Product Change Notification

Date Issued :	July 18, 2022	**PCN Number :**	511911
Reason for Change :	Change to Product		
Description of Change :	Changing the PSD drawing, removing the leading pin, changing components: insert and terminal.		
Assessment of Change :	First Article Inspection		
Planned Implementation Date :	January 18, 2023		
Sample Availability Date:	September 01, 2022		
Internal Molex Qualification Date :	September 15, 2022		
Last date to request Samples by Customer :	July 29, 2022		
Traceability Code Markings / Date :	No special marking on the product or packaging

Before Picture

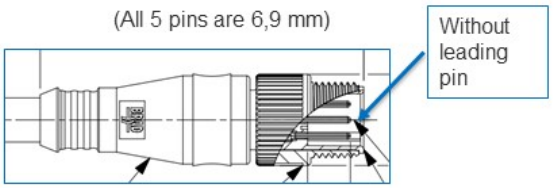
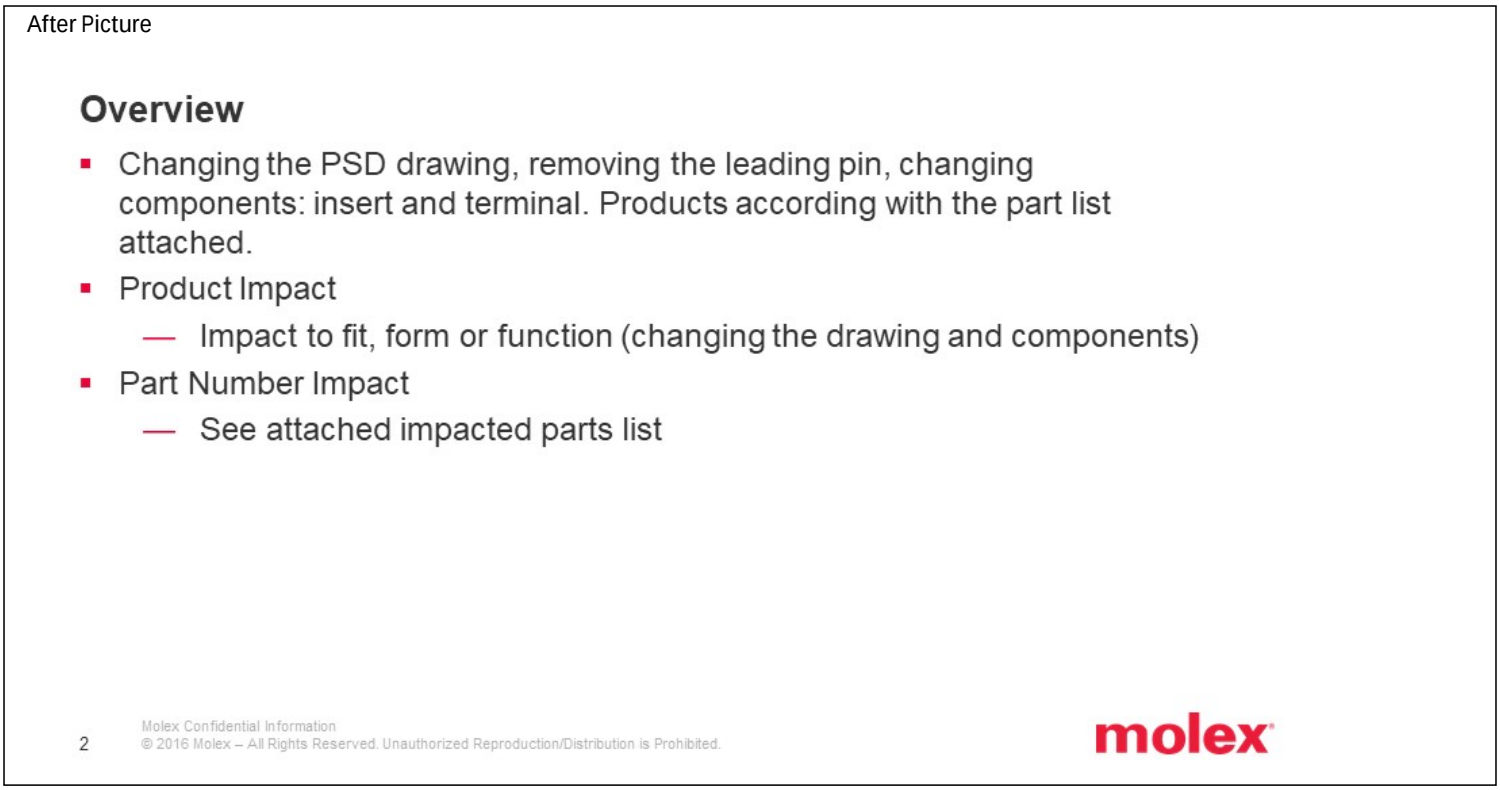
- Changing the PSD drawing, removing the leading pin, changing components: insert and terminal.

Before:
(pins 1, 2, 3, 4 are 6,9 mm
5 pin is 7,9 mm)

Insert: 1202080173
Terminal: 1202050001

After:
(All 5 pins are 6,9 mm)

Insert: 1302030018
Terminal: 1301960078
